**BEFORE THE PUBLIC UTILITIES COMMISSION
OF THE STATE OF CALIFORNIA**

Rulemaking 11-09-011
(Filed September 22, 2011)

**CLEAN COALITION COMMENTS
ON JOINT MOTIONS OF SOUTHERN CALIFORNIA EDISON COMPANY,
SAN DIEGO GAS & ELECTRIC COMPANY, AND PACIFIC GAS AND
ELECTRIC COMPANY ON LANGUAGE IMPLEMENTING JOINT COST
CERTAINTY PROPOSAL AND REVISIONS TO STREAMLINE RULE 21
FOR BEHIND-THE-METER NON-EXPORTING STORAGE DEVICES**

**CLEAN COALITION COMMENTS
ON JOINT IOU COST CERTAINTY AND ENERGY STORAGE
INTERCONNECTION MOTIONS**

Figure 2. IOU Fixed Price Option timeline (source: Joint IOU presentation).

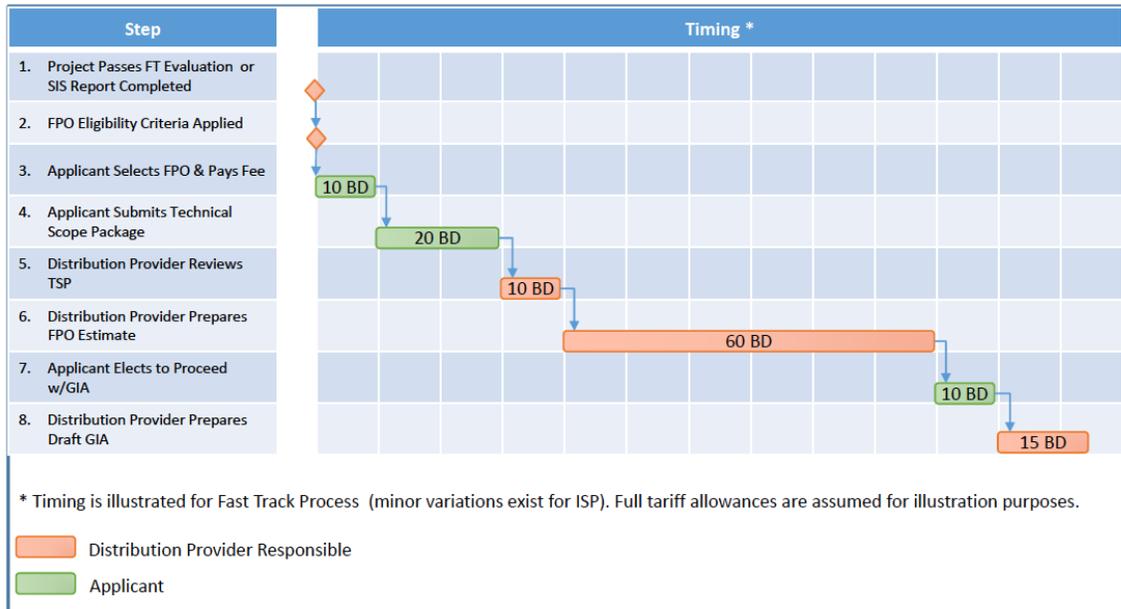
Similarly, the timeline for the FPO seems too long to be attractive to applicants. The IOU proposal adds up to 125 business days—equivalent to over five months of calendar time—to the interconnection process, including 60 days to provide the cost certainty estimate (Figure 2). For Fast Track projects this more than doubles the timeline for getting to the GIA. Combining this longer timeline with the high fees for the FPO makes this option not very attractive to developers we have surveyed. While some projects may require more than 30 days to evaluate, it is appropriate to aim for efficient processing of cost certainty requests and support this by setting a target that does not exceed the time typically required to perform the tasks. IOUs have not demonstrated the need for 60 business days, which is a very significant addition to the FT process. 30 business days (six weeks) should provide adequate time for utility staff, especially given the

While we propose no penalties for exceeding 30 days, when this target is not achieved it should be noted and explained in the Interconnection Data Quarterly Report to assist in identifying future areas for improvement. As utilities develop their new processes and utilize additional automation technologies we anticipate that the time required will decrease.
